# VAN'S AIRCRAFT

## NOTIFICATION 17-12-08

**Subject:** Canopy Latch/Handle Upgrade

**Affected Models:** All RV-12 Aircraft

**FIGURE 1: ADDING C-01215-1**

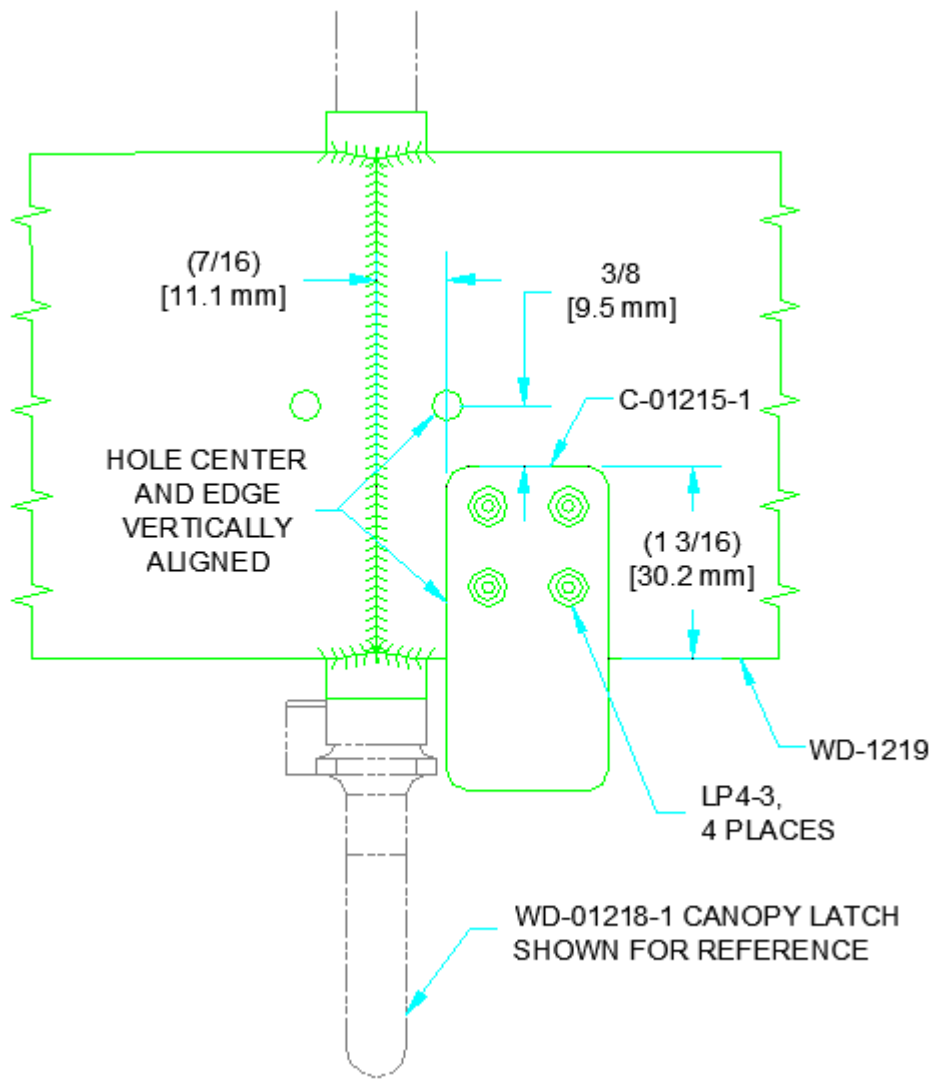
Step 2: Install the C-1215-1 Latch Handle Stop as shown in Figure 1. If installing the canopy handle for the first time use the dimensions to position and match-drill #30 the latch handle stop to the WD-1219 Canopy Frame.

**FIGURE 2: PILOT DRILL CANOPY HANDLE**

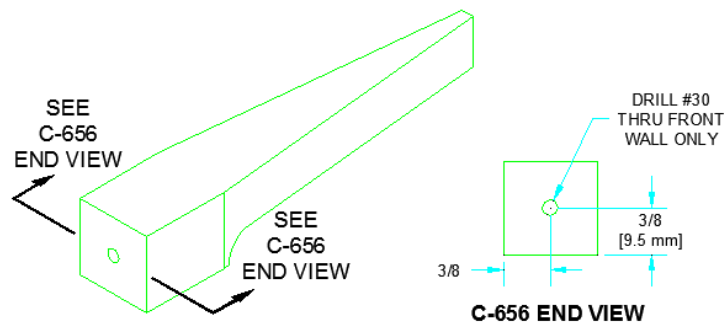
Step 3: Drill a pilot hole in the end of the C-656 Canopy Handle as shown in Figure 2. Be sure to drill perpendicular to the face of the Canopy Handle.

**FIGURE 3: CANOPY HANDLE ASSEMBLY**

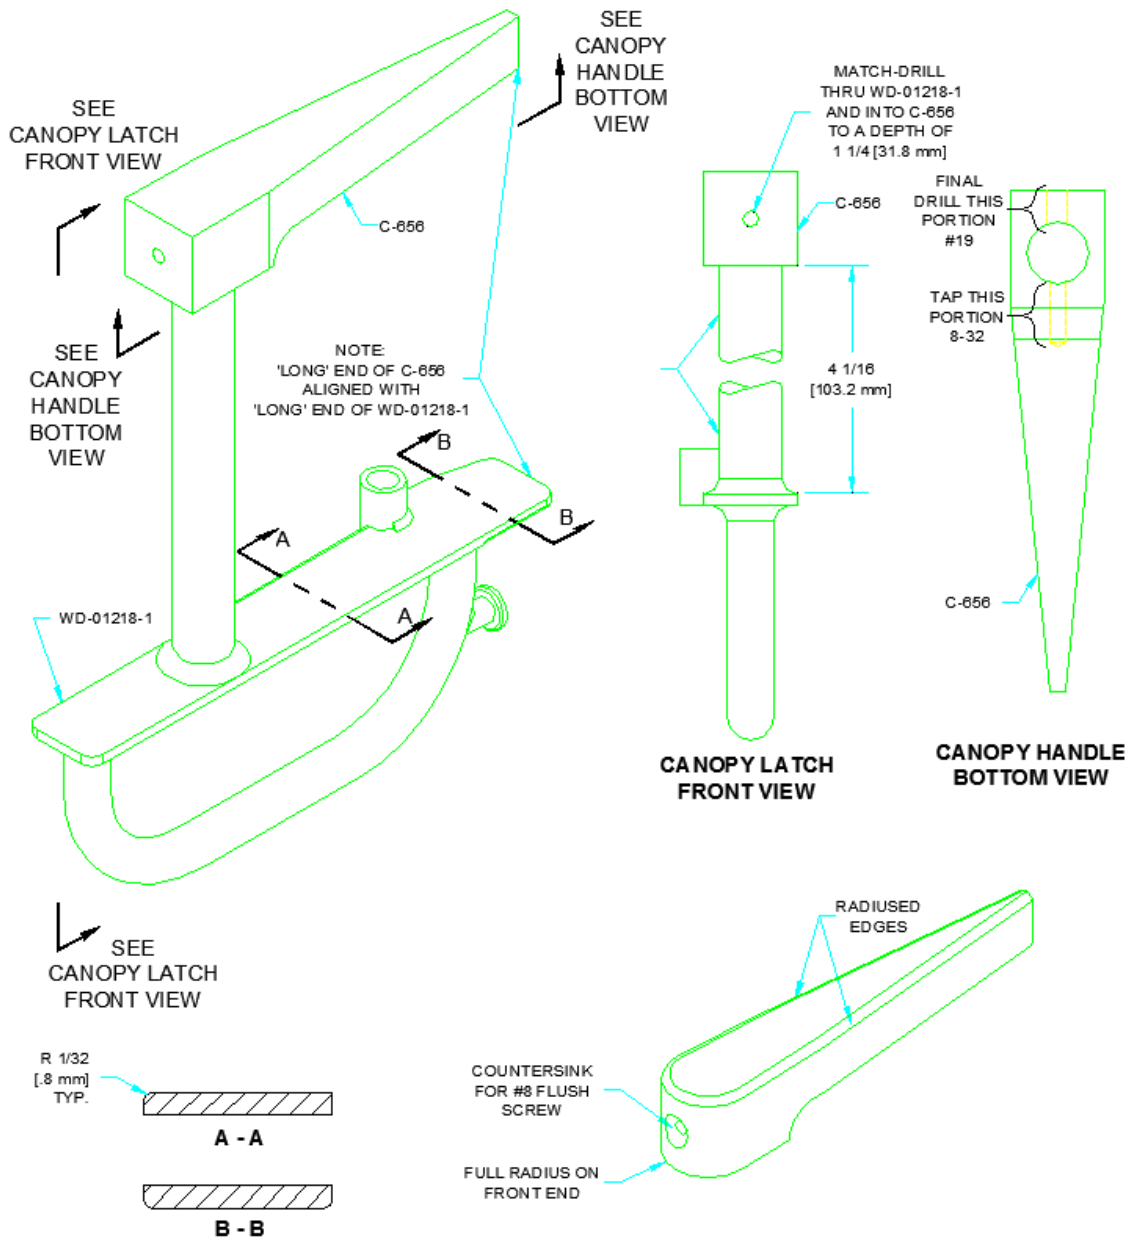
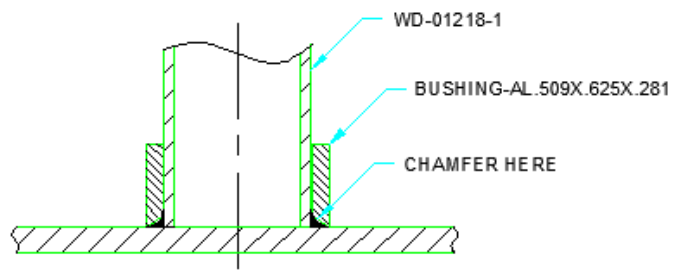
Assemble the WD-01218-1 Canopy Latch and C-656 Canopy Handle as shown in Figure 3. The tube end of the canopy latch may be shortened if/as required to achieve the dimension called out in Figure 3.

Using the pilot hole in the canopy handle as a drill guide, match-drill #30 through both sides of the canopy latch tube and into the canopy handle to the depth called out in Figure 3.

Round off the edges of the latch plate as shown in Figure 3 Sections A-A and B-B. The canopy handle edges and ends may be rounded if/as desired. See Figure 3 for an example of a final shape.

**FIGURE 4:** CANOPY LATCH INSTALLATION

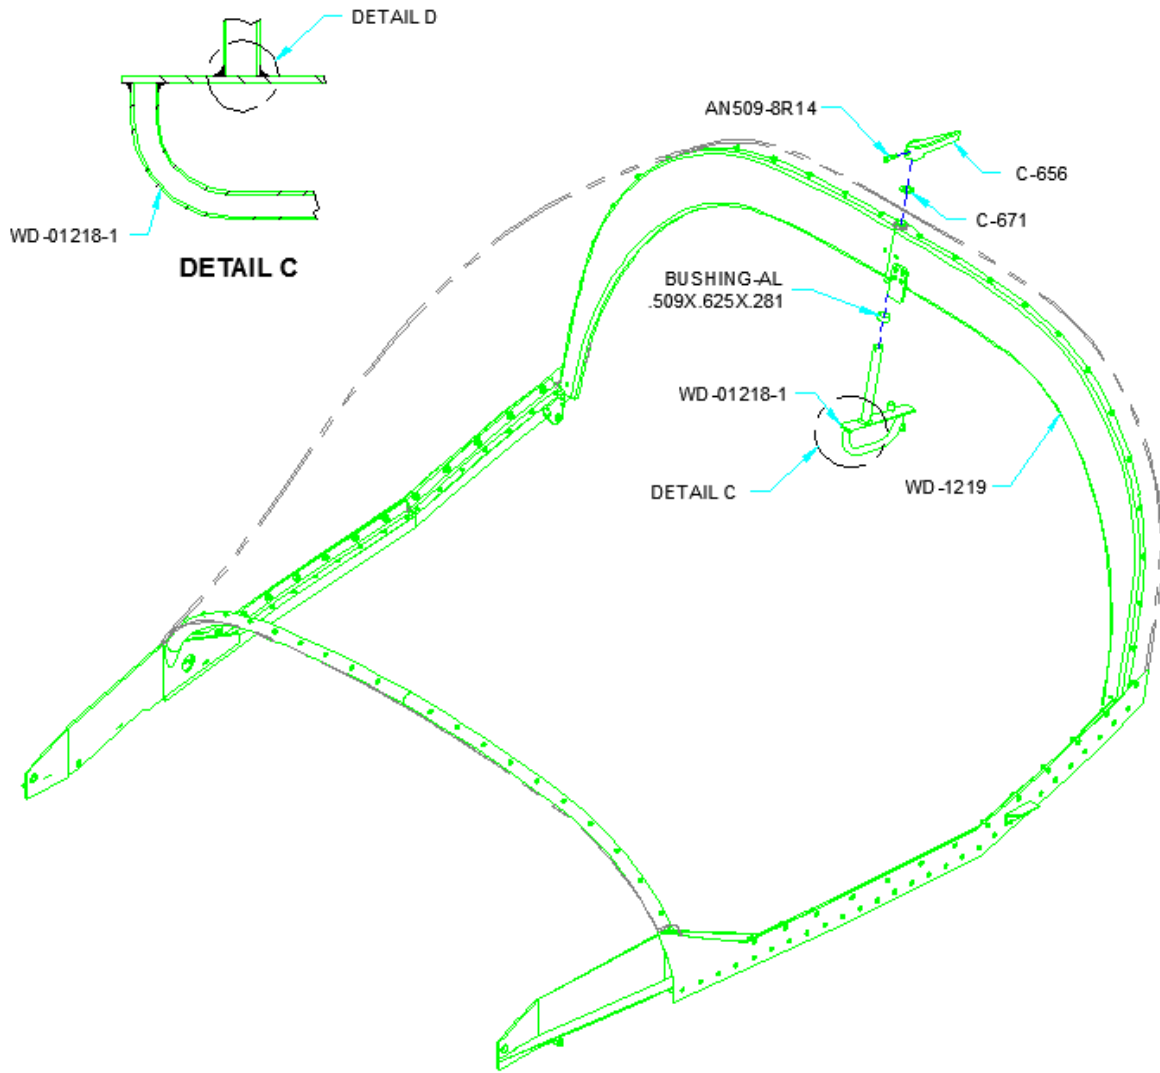
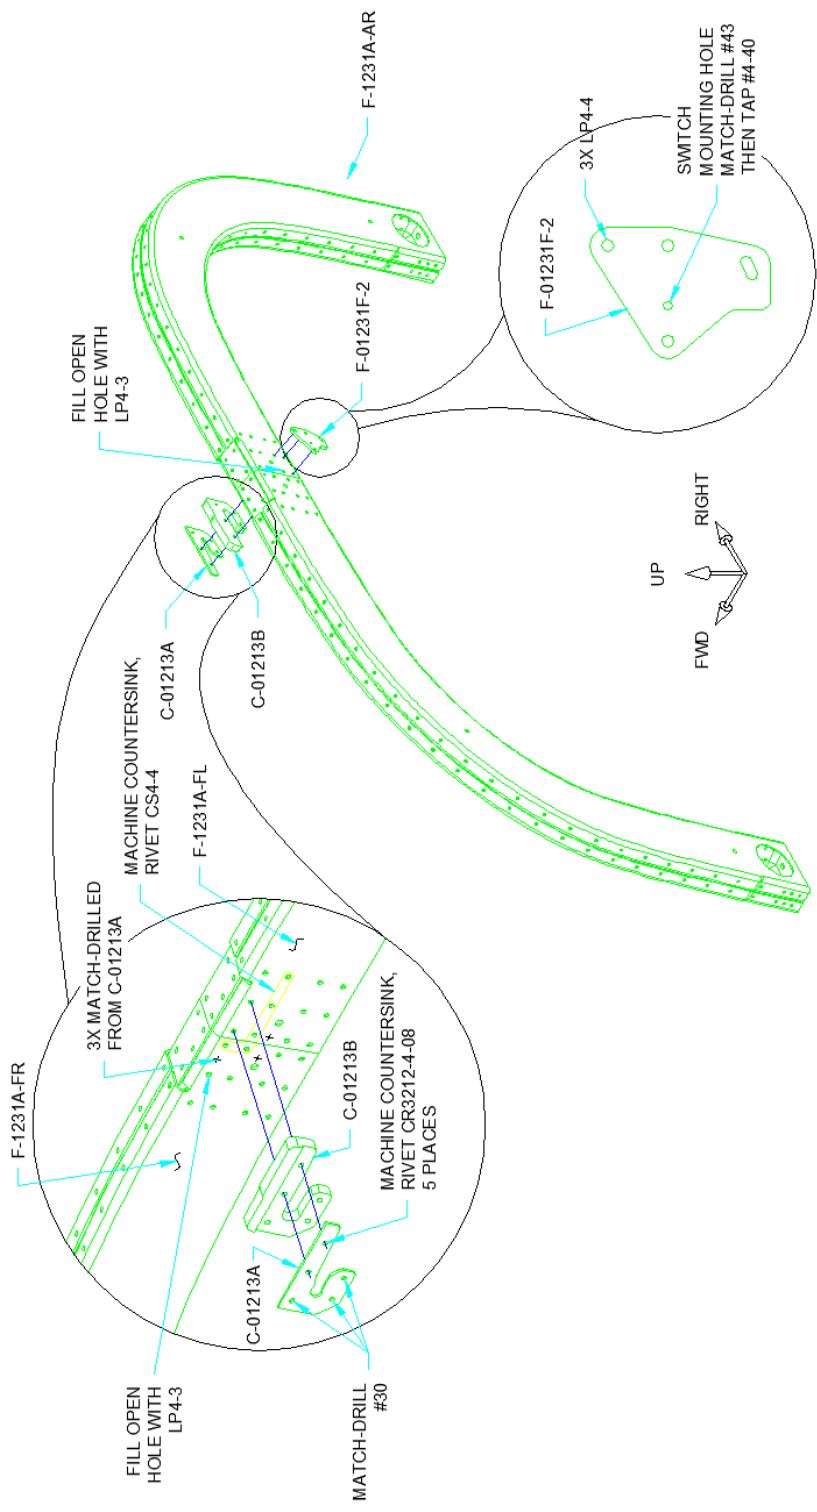
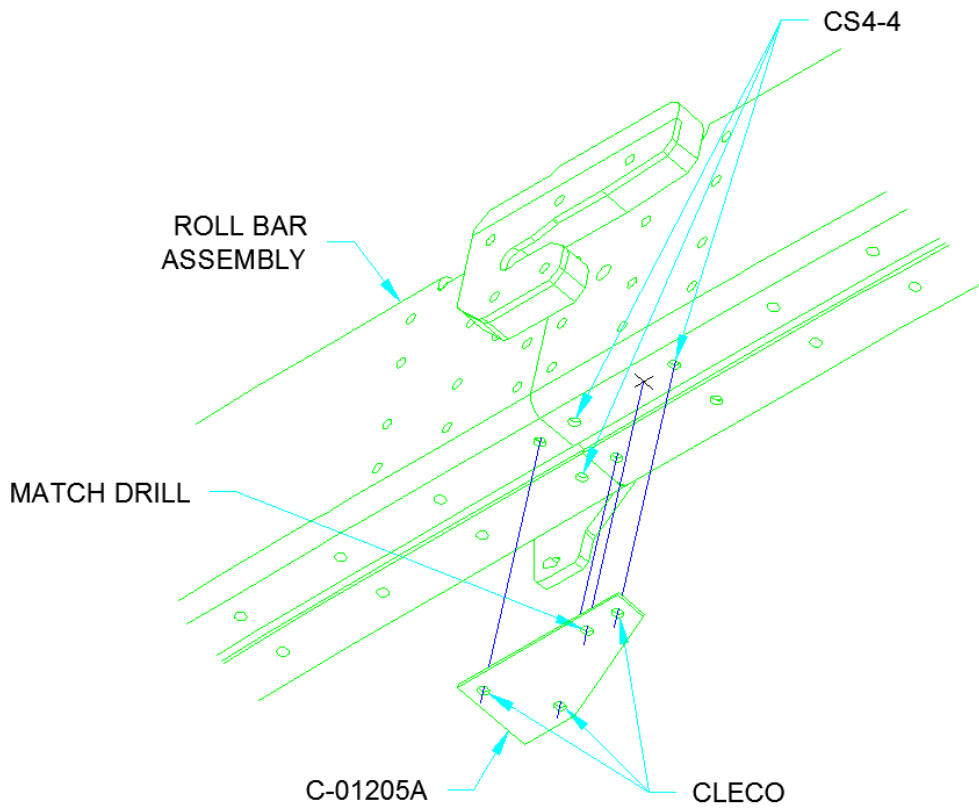
Step 4: Chamfer the inside of BUSHING-AL.509X.625X.281 allowing it to sit lower on the WD-01218-1 Canopy Latch tube as shown in Figure 4.

Step 5: Install the WD-01218-1 Canopy Latch, called out bushing, C-671 Plastic Washer and C-656 Canopy Handle on the WD-1219 Canopy Frame as shown in Figure 4.

**FIGURE 5: ROLL BAR UPDATE**

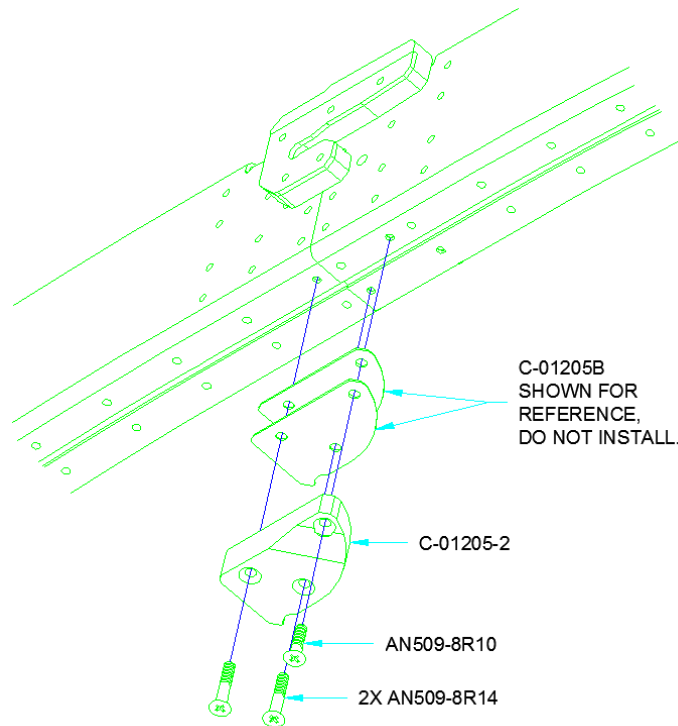
Step 6: Machine countersink C-01213A for the heads of the rivets called out in the detail view in Figure 5.

Step 7: Remove the previously installed rivets and then machine countersink the five holes on the forward face of the Roll Bar Assembly indicated in the detailed view of Figure 5.

Step 8: Cleco the F-01231F-2 to the Roll Bar Assembly. Match-Drill #43 the switch mounting hole of the F-01231F-2 into the Roll Bar Assembly. See the detail view in Figure 5.

Step 10: Rivet C-01213A and C-01213B to the Roll Bar Assembly. See Figure 5.

Step 11: Fill the open holes on the front and back sides of the roll bar frame as called out in Figure 5.

**FIGURE 8: SHIM INSTALLATION**

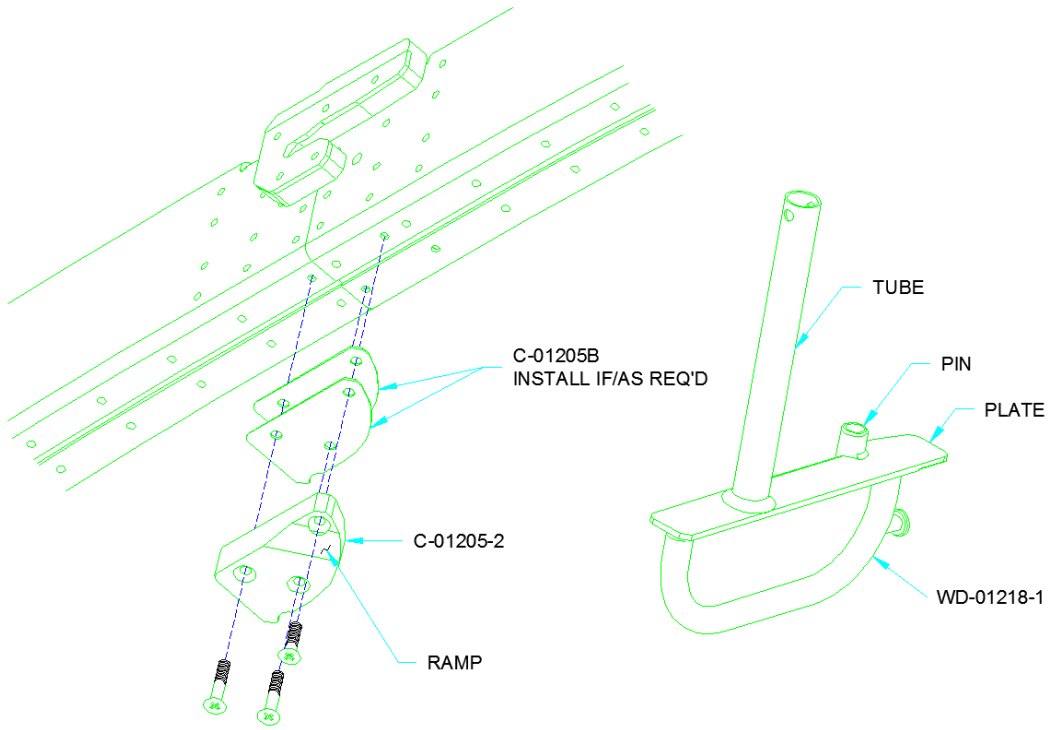
If there is any gap between the top surface of the latch plate and the lower surface of the guide block that allows canopy movement when you pull down firmly on the handle (even though the latch is fully closed and the latch pin contacts the stop) remove the guide block and add one or two C-01205B Shims between guide block and roll bar to lower the block and eliminate the gap. See Figure 8.

It is acceptable for the latch plate to strike the ramped portion of the block. See Figure 8. If the latch action is difficult adjust or trim the canopy seals to correct the latch action. If the handle needs to move downwards to improve the latching action replace the C-671 Plastic Washer and BUSHING-AL.509X.625X.281 installed in Steps 4 and 5 with the C-01223 Canopy Latch Spacer and

**FIGURE 9: CANOPY LATCH SWITCH INSTALLATION**

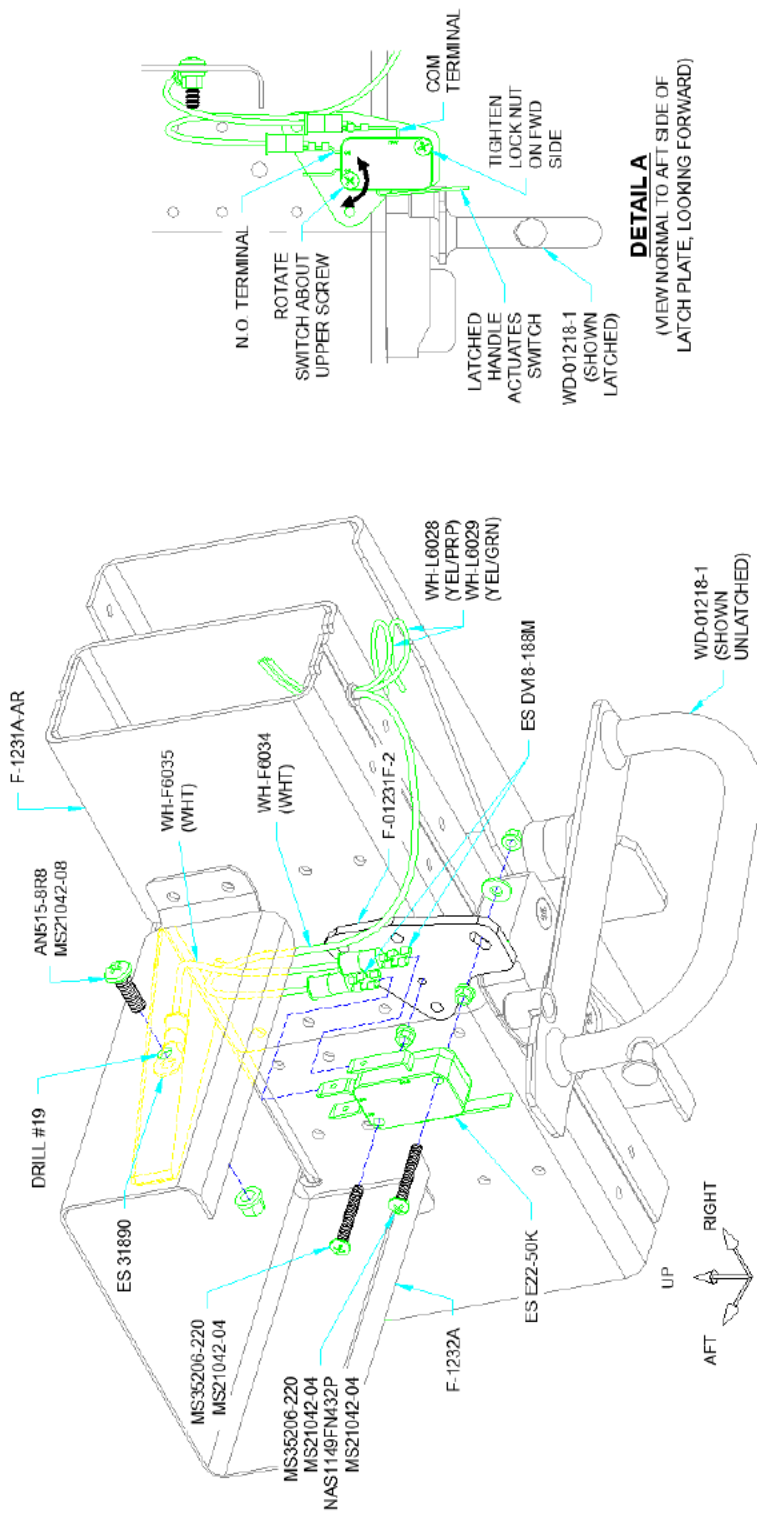
Step 23: Install the micro switch on the F-01231F-2 Latch Plate as shown in Figure 9. Insert the screws into the micro switch mounting holes and thread on the two lock nuts. Orient the lock nuts so that the flanges will contact the latch plate. **DO NOT** apply more than 3 in-lb beyond prevailing torque to the two lock nuts against the switch.

Secure the micro switch by tightening the lock nut against the washer on the forward side of the latch plate. See Detail A in Figure 9.

**FIGURE 10: MODIFYING THE RETAINERS**

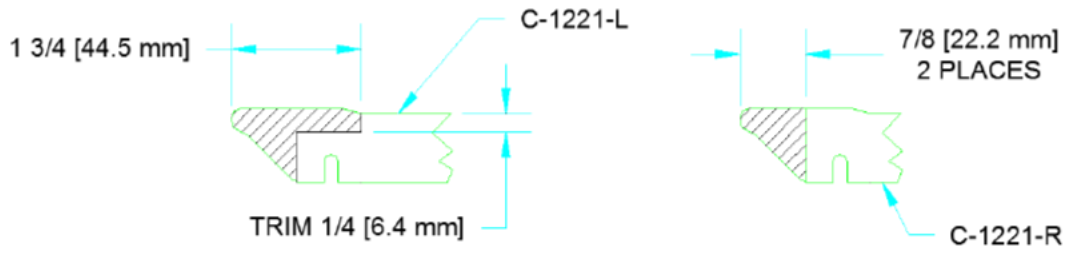
Step 18 (Seal Kit Installed): If a seal kit is installed remove and modify the C-1221-L & -R Seal Retainers as shown in Figure 10 to provide clearance between the retainers and the canopy block. Deburr and bevel the edges at the screw slots as shown in Figure 10, if desired, which aids in sliding the retainer beneath the washers.

**FIGURE 11: FABRICATE THE LATCH SEAL**

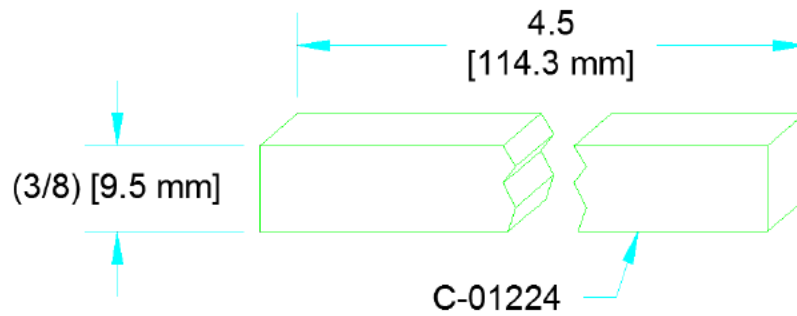
Step 20 (Seal Kit Installed): Fabricate the C-01224 Latch Seal from SEAL-00003 Foam PVC .375X.625 per Figure 11. Add relief notches for the canopy fasteners and canopy handle tube as shown in Figure 12.

**FIGURE 12: CANOPY UPPER CENTER SEAL BOTTOM VIEW**

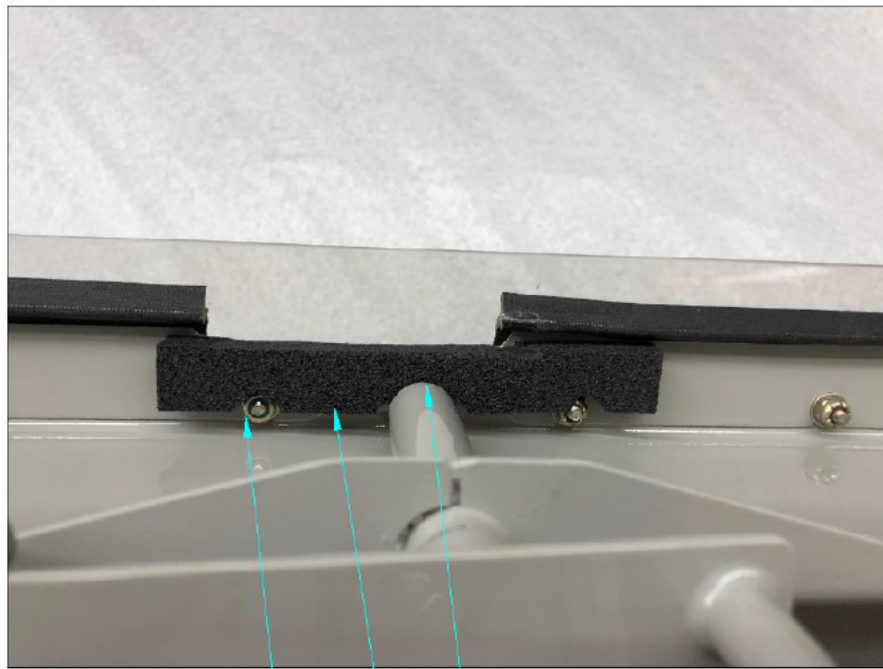
Step 19 (Seal Kit Installed): Trim the C-1220-L/R Roll Bar Seals to match the modified C-1221-L & R Seal Retainers. See Figure 12 and Figure 13.

Open the canopy and use the edge of the tape to position the C-01224 as shown in Figure 12. Remove the adhesive backing attach C-01224 to the canopy frame assembly.
